PRIMARY ROAD SYSTEM
CHICKASAW COUNTY
 CCS BRIDGE REPLACEMENT

US 18 - Winters Lake Overflow 2.9 mi E of Co Rd T76

Field Exam Mark-up

Field Exam was held by Teams Mtg on 5/5/2021

DETOUR ROUTE

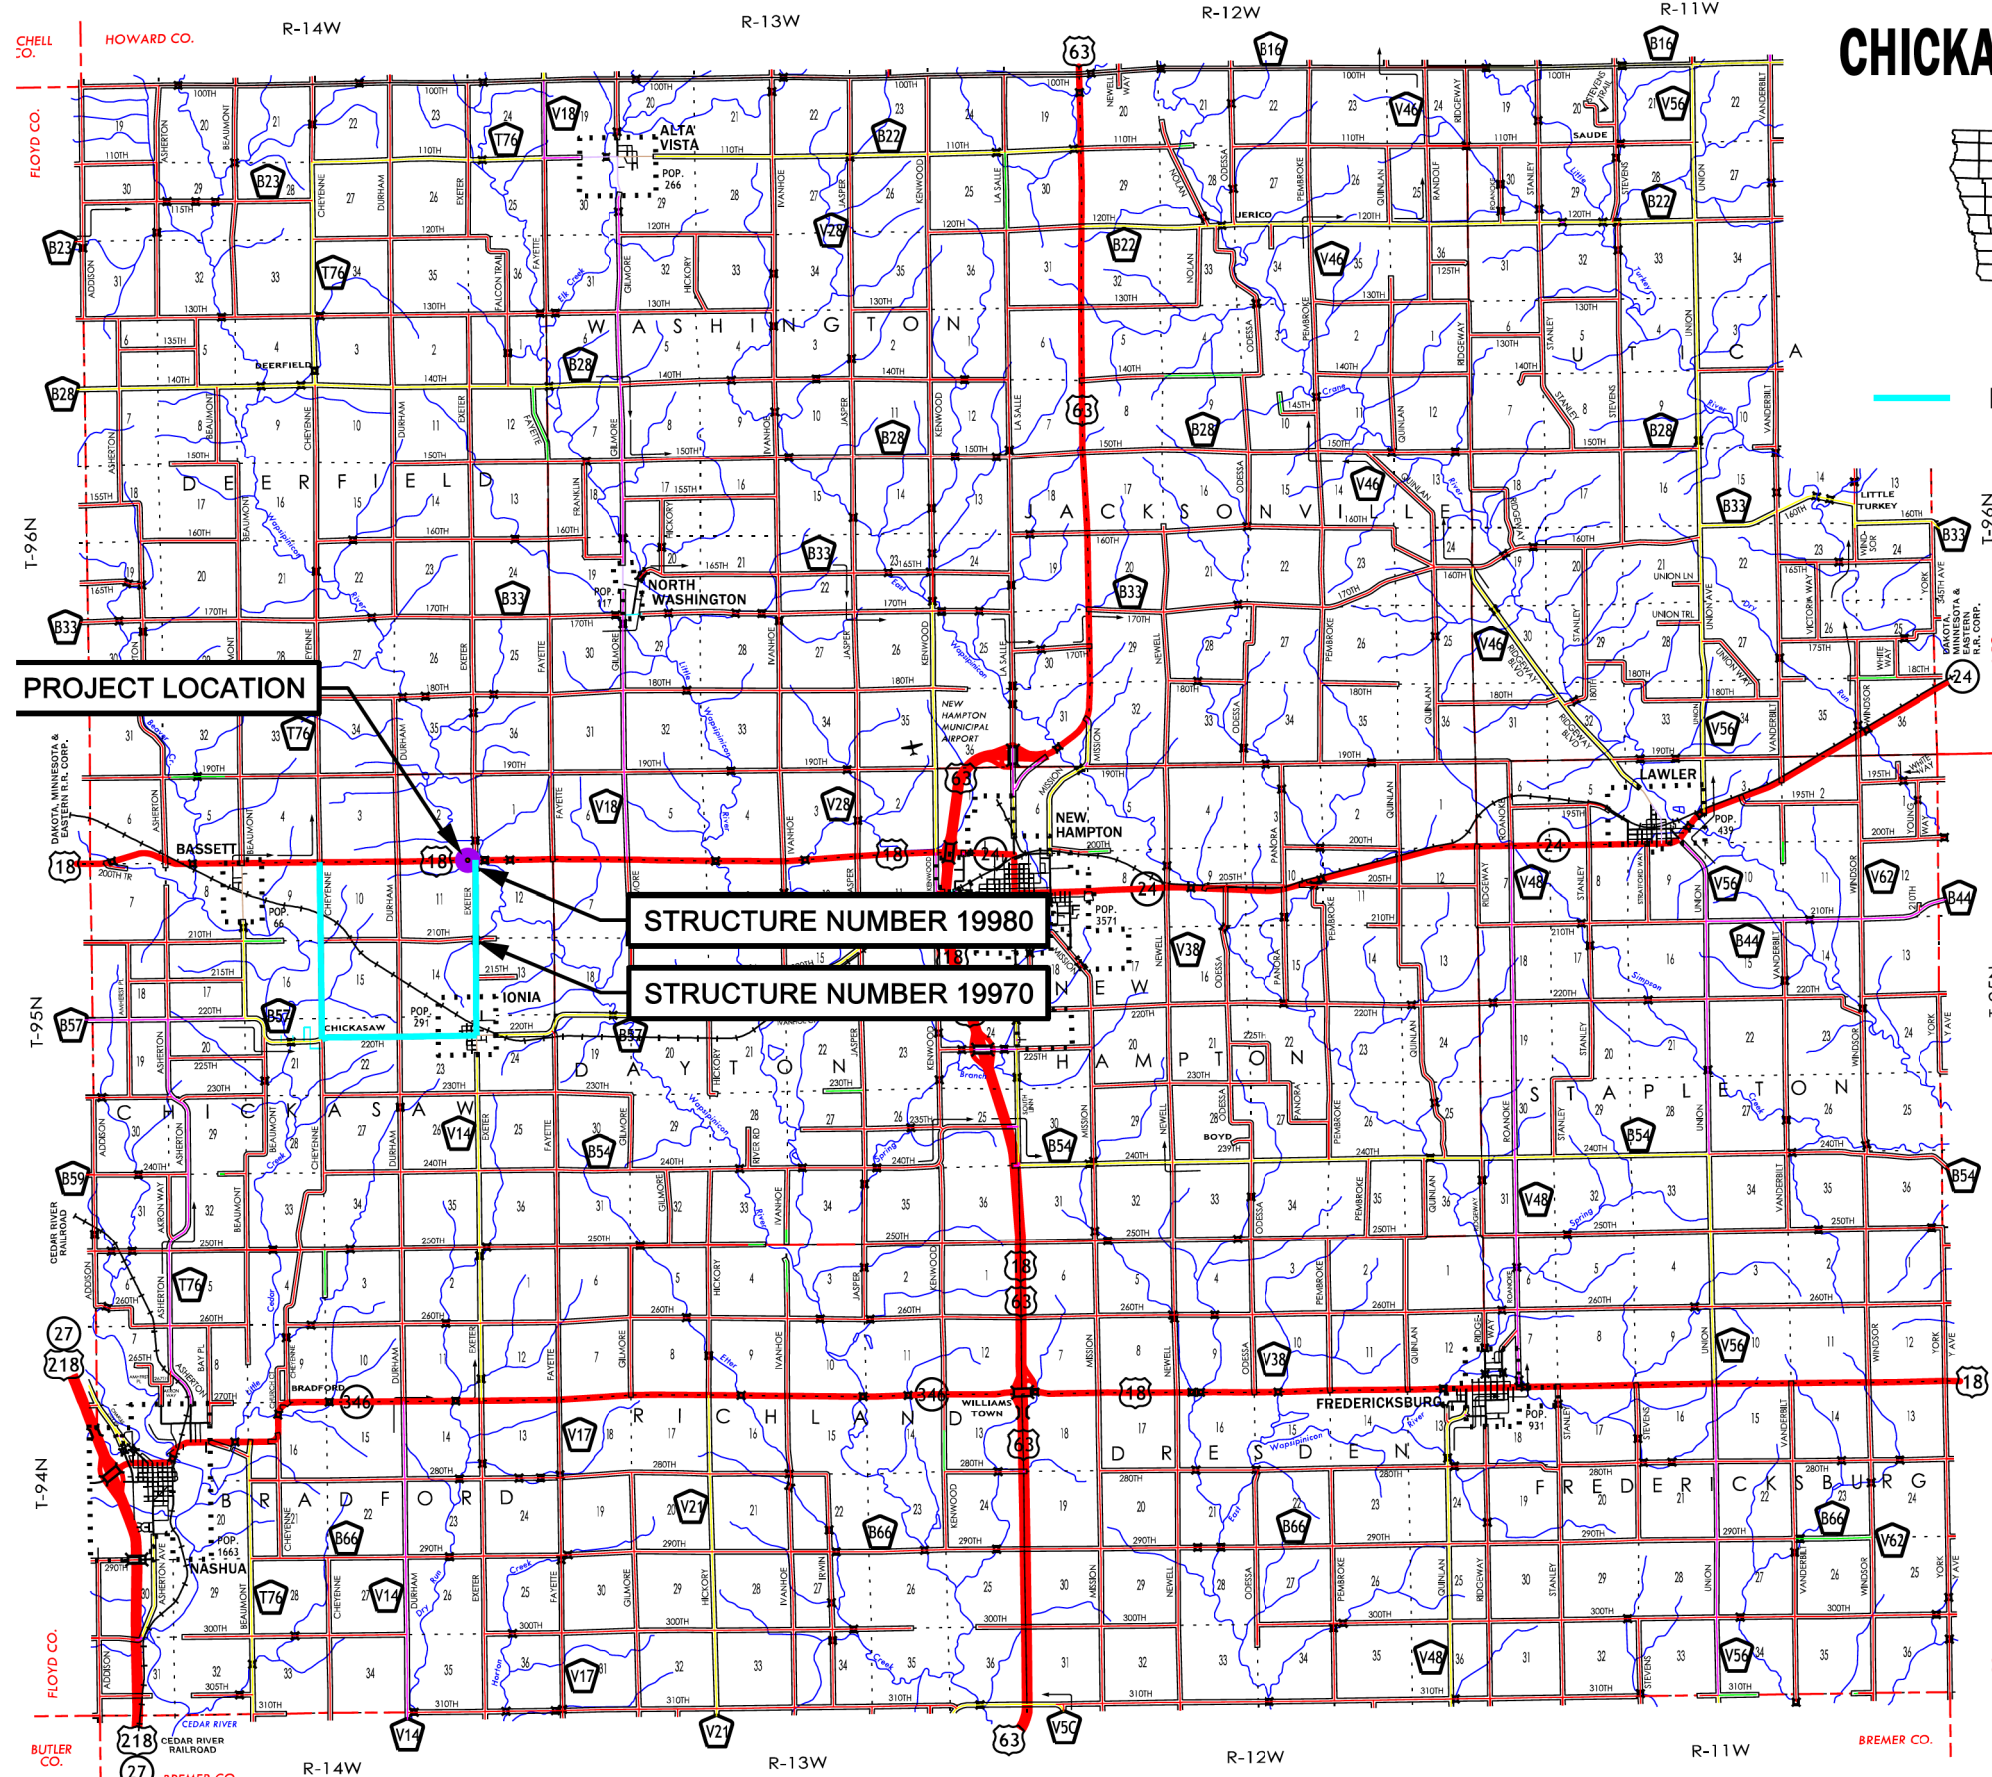
Detour route good as shown.
District will prepare signing
plan and install/maintain signs
during construction

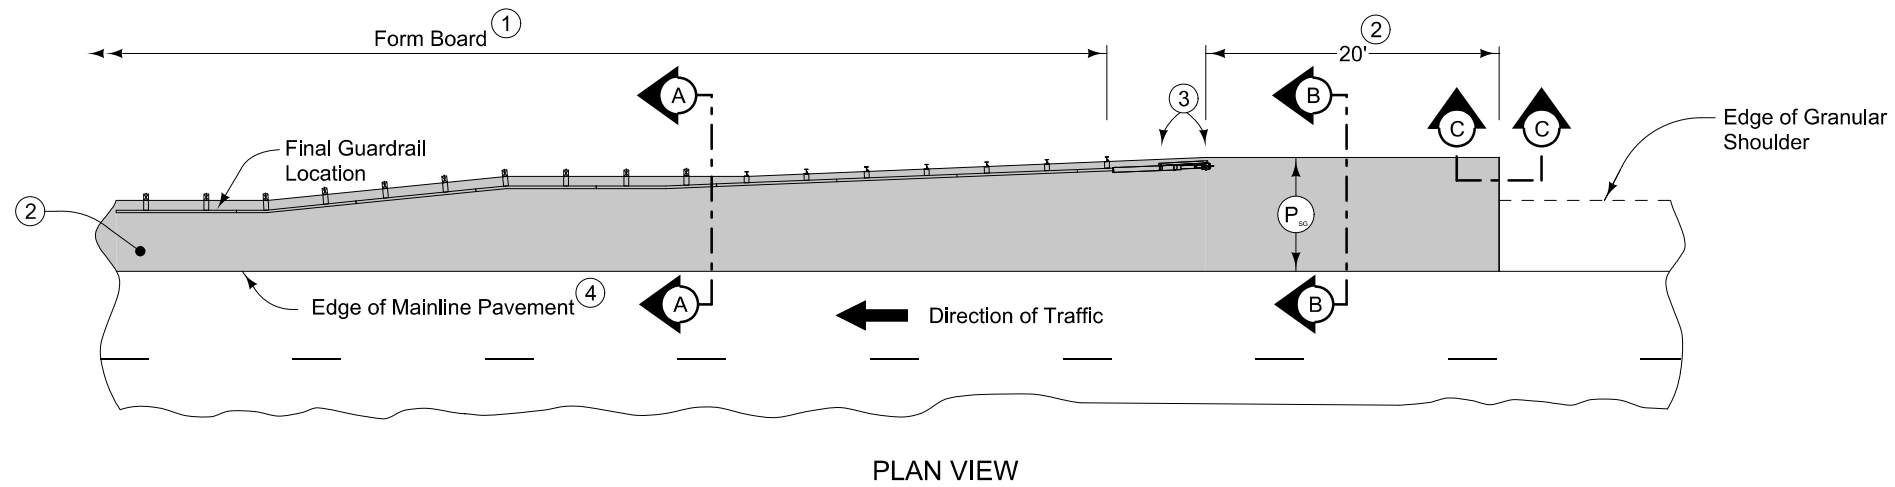
Extend paving limits to lead edge of paved shoulder for guardrail
